Request	-	Minor Site Plan Review
Location	-	847 W Alexis Road
Applicant	-	Larry Wilson 3108 Vestal Parkway East Vestal, NY 13850
Owner	-	JLS Alexis LLC 3440 Secor Road Toledo, OH 43606
Engineer	-	Moises Lozano Toth Associates 1550 E. Republic Road Springfield, MO 65804

APPEAL OF CONDITIONS OF APPROVAL  
MINOR SITE PLAN REVIEW  
TOLEDO CITY PLAN COMMISSION  
REF: SPR-15-24  
DATE: August 8, 2024  
TIME: 2:00 P.M.

## New Draft Minor Site Plan Review Approval

**RE: Minor Site Plan Review for a new drive-thru coffee shop at 847 W. Alexis Road**  
**PC File: SPR-15-24**

C 2.1  
SITE PLAN  
DATE: MARCH 21, 2024  
H. SCALE: 1" = 10'

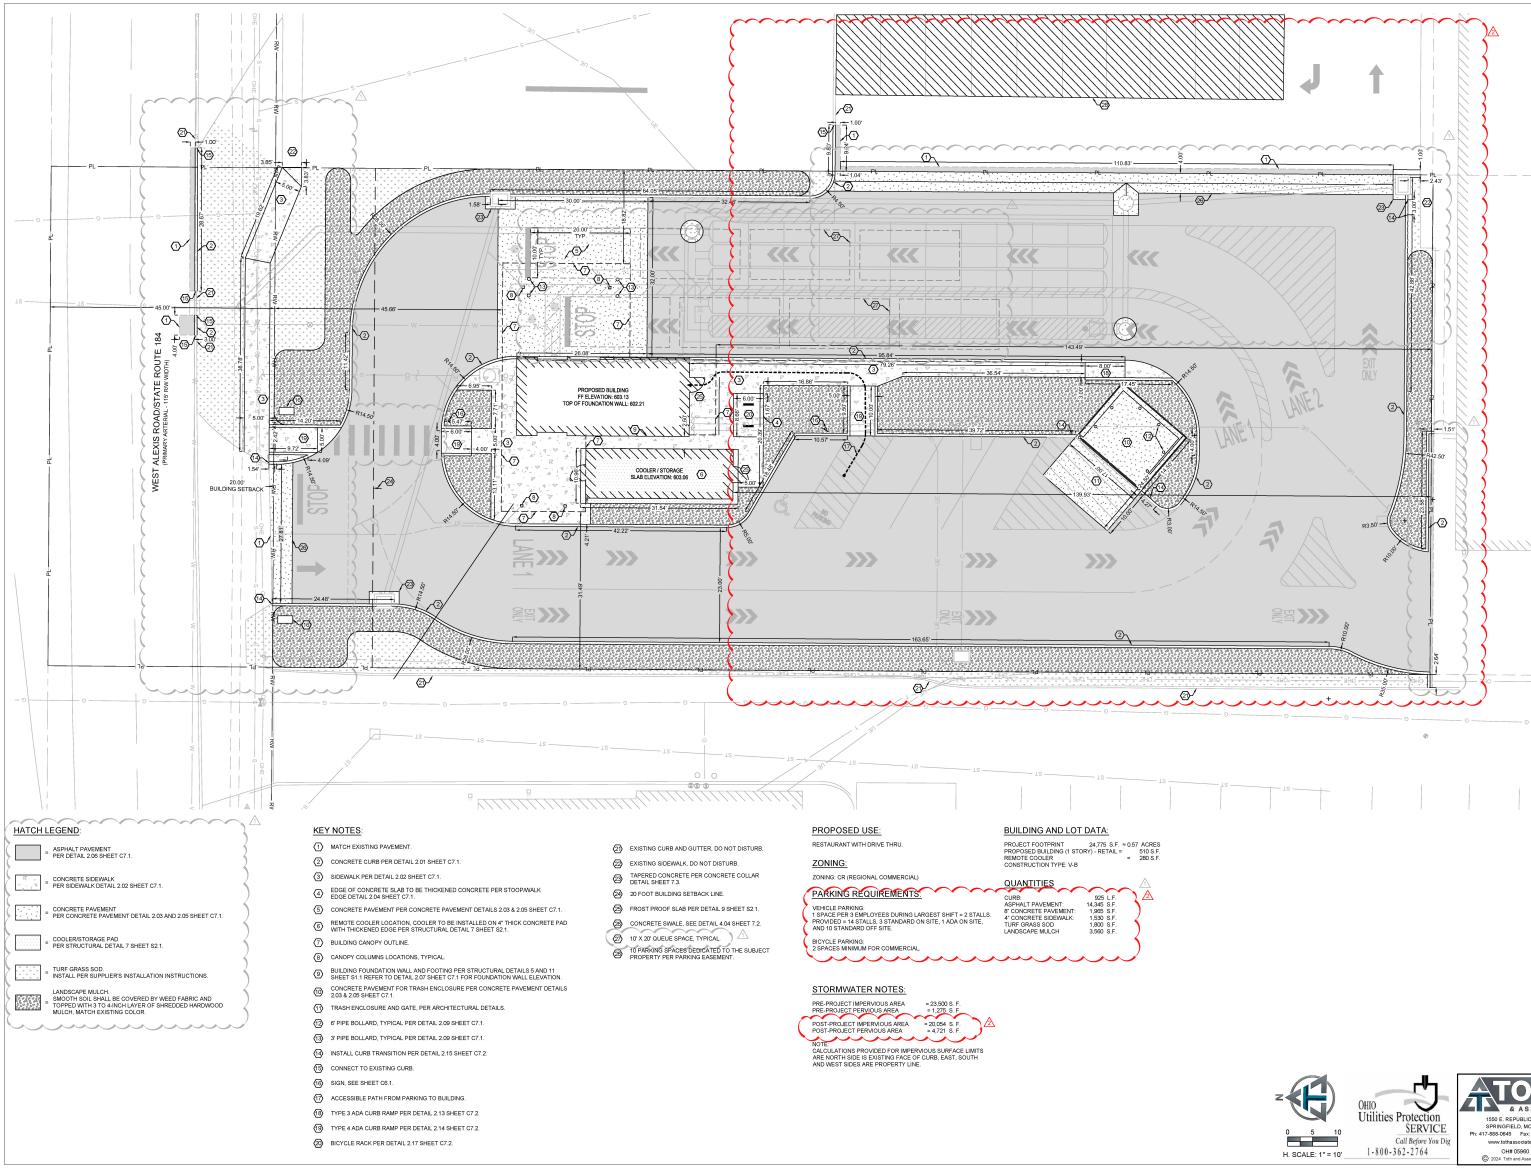
22. Van-accessible spaces must have at least an 8-foot wide aisle abutting the designated parking space. **Not acceptable as depicted. A revised site plan shall be submitted depicting an 8-foot wide aisle abutting the designated accessible parking space.**

25. The eastern "Exit Only" drive aisle shall be widened to twenty feet (20') in width per the 2017 Ohio Fire Code §503.2.4. **Not acceptable as depicted. A revised site plan shall be submitted depicting the eastern "Exit Only" drive aisle widened to twenty feet (20').**

# LANDSCAPE PLAN

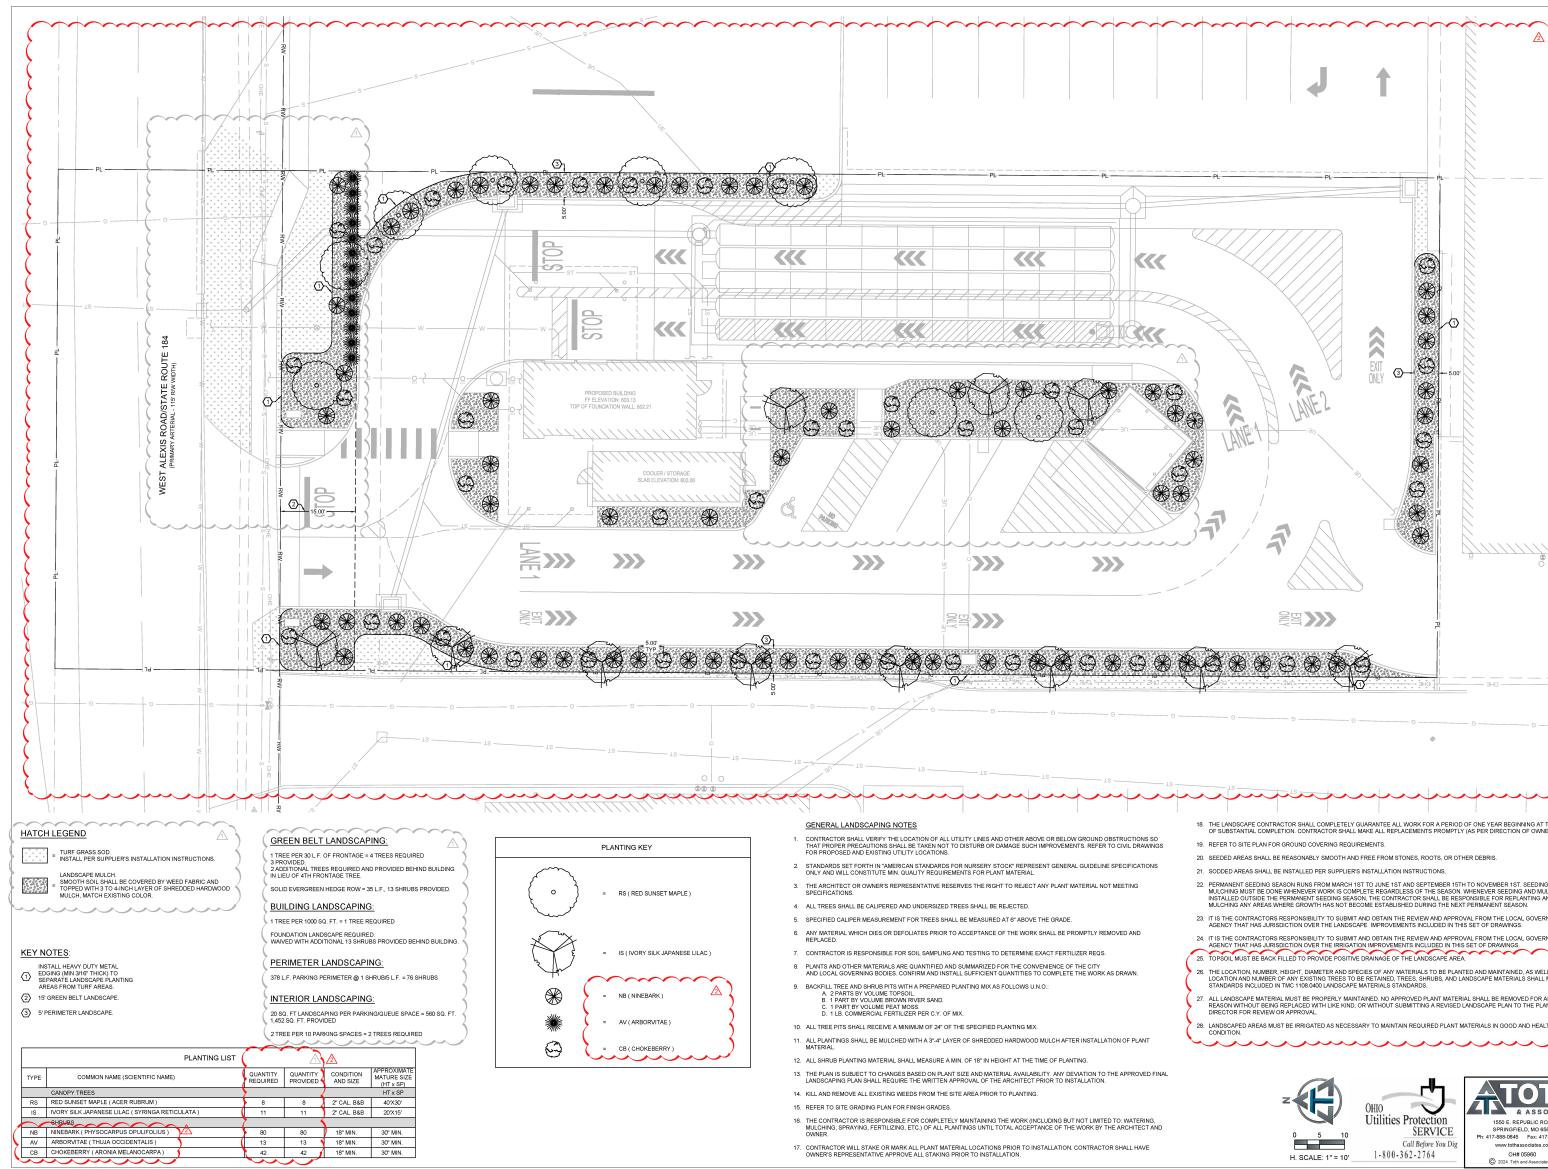
The applicant is requesting that a five-foot (5') perimeter landscape be accepted in lieu of the ten-foot (10') requirement. They are proposing to compensate for these shorter perimeter landscaping areas by placing additional plantings within the interior landscaping island. Staff finds this compromise acceptable, so long as the additional plantings are placed within the landscape island required by condition 28c. The applicant also requests the use of smaller trees in the western perimeter landscaping due to existing overhead utility lines. Staff finds this acceptable as well.

The applicant contends that a landscape island in this stripped area will create an obstruction causing large vehicles, trash collection trucks, and emergency vehicles to have a difficult time navigating the site. Staff consulted with the Fire Prevention Bureau regarding this condition’s effect on emergency vehicle navigation. The Bureau did identify a potential issue; however, this can be rectified by widening the “Pass Thru” lane, now labeled the “Exit Only” lane, to twenty feet (20'). This was the only issue identified by the Bureau. As such, a condition has been added that the applicant widen the eastern “Exit Only” lane connecting to the property to the east to twenty feet (20'). A somewhat smaller landscaping island will be required in the remaining area between.

d. A landscape buffer shall be depicted between the “Lane 2” drive aisle and a line twenty-three feet (23’) from the western edge of the parking spots depicted on the adjacent property, connecting the required ten-foot (10’) landscape buffer to the north and the required landscape island between the “Lane 2” and “Pass Thru” drive aisles. This landscape buffer shall be covered with hardwood mulch, grass or other vegetative ground coverage. Shrub and/or native grass plantings are encouraged but not required within this landscape buffer. **Not acceptable as depicted. A revised site and landscape plan shall be submitted depicting a landscape buffer between the “Lane 2” drive aisle and twenty-three feet (23’) from the western edge of the parking spots depicted on the adjacent property.**

The applicant contends that a landscape buffer in this area would invalidate an easement granted on April 18<sup>th</sup>, 1994 between the applicant’s property and the adjacent property currently occupied by OfficeMax. The easement is attached to this report as Exhibit B. This easement establishes three agreements relevant to this appeal, the first of which is “a nonexclusive easement of access to be provided by means of one point of entry twenty nine (29) feet wide between the [OfficeMax] Parcel and the [applicant’s] Parcel, at the location designated on Exhibit C...” Exhibit C of the easement, part of Exhibit B of this report, shows this access easement at the south west of the property. Ingress and egress for this access easement agreement will not be impeded by the conditioned landscape strip.

-ment prohibits the owner of the OfficeMax parcel from constructing any barrier between the parking spots and the property line, but it does not prohibit the applicant from constructing such a barrier. The construction of this landscape strip by the applicant will not invalidate this agreement, nor will it invalidate the language of the overall easement. The conditioned landscape barrier will provide safety for vehicles stacking in the applicant's drive-thru lanes and it will reduce the urban heat island effect, which is a strategy laid out in the Forward Toledo Comprehensive Land Use Plan.

- b. Perimeter landscaping must be installed along any parking lot area adjacent to a street, place, or driveway, or which is visible from an immediately adjacent property. Perimeter landscaping must consist of a landscape area at least 10 feet in width, exclusive of sidewalks, walkways, trails, or right-of-way and must be located between the parking lot and the property line. A minimum of at least one (1) canopy tree must be provided for each thirty feet (30'), plus a continuous shrub with a minimum height of 18 inches (when installed so as to achieve full screening at maturity) **Not acceptable as depicted. Perimeter landscape buffer may be five feet (5') in width so long as at least two (2) canopy trees and eight (8) shrubs are planted within the required landscape island between "Lane 2" and the eastern "Exit Only" lane. Two (2) additional canopy trees are required within the southern perimeter landscaping. Trees within the western perimeter landscaping may be smaller trees due to existing utility lines. A revised landscaping plan shall be submitted depicting two (2) canopy trees within the southern perimeter landscaping.**

- c. A landscape island shall be depicted in the area between the "Lane 2" and eastern "Exit Only" drive aisles to break up the urban heat island. This landscape island must be covered with hardwood mulch, grass or other vegetative ground coverage. Two (2) canopy trees and eight (8) shrubs are required within this landscape island. **Not acceptable as depicted. A revised site and landscape plan shall be submitted depicting a landscape island containing two (2) canopy trees and eight (8) shrubs between the "Lane 2" and "Pass Thru" drive aisles.**

- d. A landscape buffer shall be depicted between the "Lane 2" drive aisle and a line twenty-three feet (23') from the western edge of the parking spots depicted on the adjacent property, connecting the required landscape buffer to the north and the required landscape island between the "Lane 2" and eastern "Exit Only" drive aisles. This landscape buffer shall be covered with hardwood mulch, grass or other vegetative ground coverage. Shrub and/or native grass plantings are encouraged but not required within this landscape buffer. **Not acceptable as depicted. A revised site and landscape plan shall be submitted depicting a landscape buffer between the "Lane 2" drive aisle and twenty-three feet (23') from the western edge of the parking spots depicted on the adjacent property.**

A2.1  
EXTERIOR ELEVATIONS

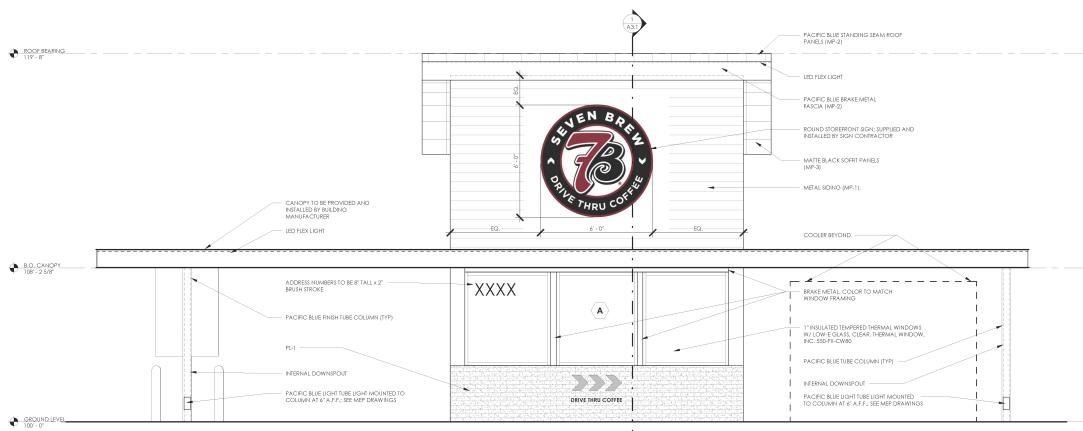
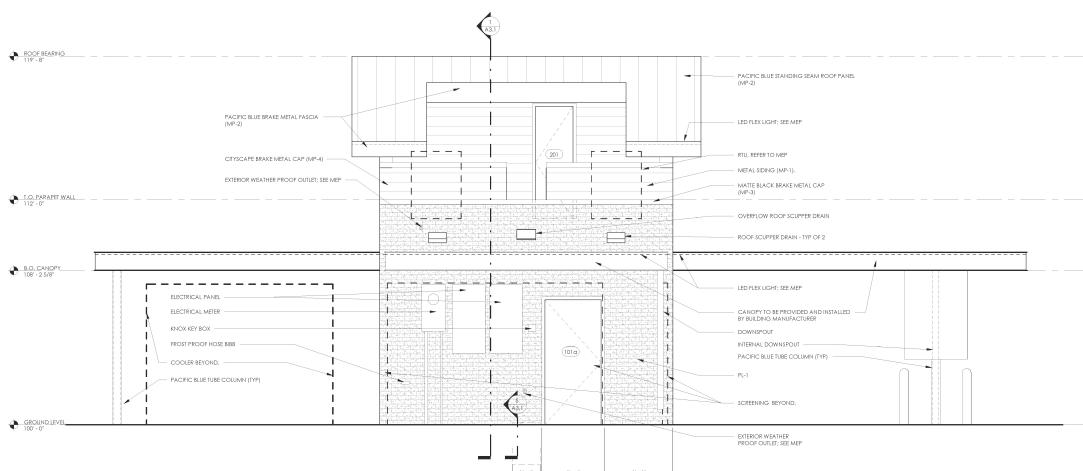
31. Predominant exterior building materials shall be high-quality materials. For façades visible from the public right-of-way, predominant materials must comprise at least eighty percent (80%) of the total wall area of the façade. **Acceptable as submitted.** *Breakdown of submitted materials are as follows, names are based on what is shown on elevation sheets:*

- A. Front elevation: 57.9% Architectural Metal, 25.7% Glass Storefront, 16.4% Brick. Glazing composes 58.9% of the elevation from 2' to 10' in height.
- B. Right-side elevation: 64.9% Architectural Metal, 13.4% Glass Storefront, 21.6% Brick. Glazing composes 19.9% of the elevation from 2' to 10' in height.
- C. Left-side elevation: 48.6% Architectural Metal, 27.6% Glass Storefront, 23.7% Brick. Glazing composes 40.5% of the elevation from 2' to 10' in height.
- D. Back elevation: 36.7% Architectural Metal, 0% Glass Storefront, 63.3% Brick. Glazing composes 0% of the elevation from 2' to 10' in height.
